CITY OF ROCKVILLE HISTORIC DISTRICT COMMISSION STAFF REPORT

for July 20, 2006 MEETING NO. 07-06

APPLICATION: HDC2006-00363

REQUEST: Approval for wall entry feature at W. Montgomery Avenue/Laird Street

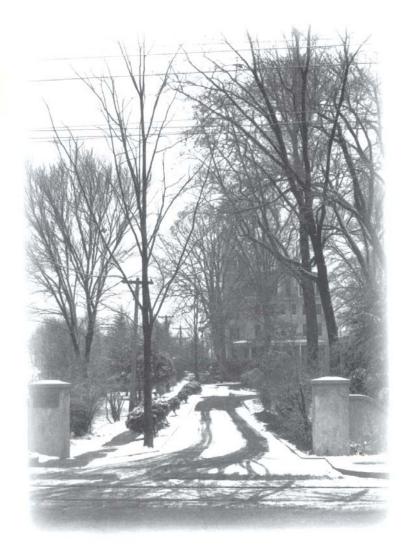
The proposed entry feature will be constructed in a style reminiscent of the earlier curved wall and piers that existed in this location and that are partially shown below in this undated photograph:

The new wall will be built to a larger scale that is more compatible with the wider vehicle and the added pedestrian entries.

The applicant's landscape architect, Sunny Scully, described the proposed entry feature design at the HDC Courtesy Review on June 15, 2006. She said that the old photograph shown above indicates that the earlier square piers that were once in this location were approximately 8 feet tall. In her design, she added an extra column on each side of the road and extended the length of the wall on each side. This was done because the scale of the entrance is going to be widened to accommodate three vehicle lanes and a separate pedestrian walkway. The Chestnut Lodge frontage along West Montgomery Avenue is approximately 500 feet and the proposed elongated design is in scale with that.
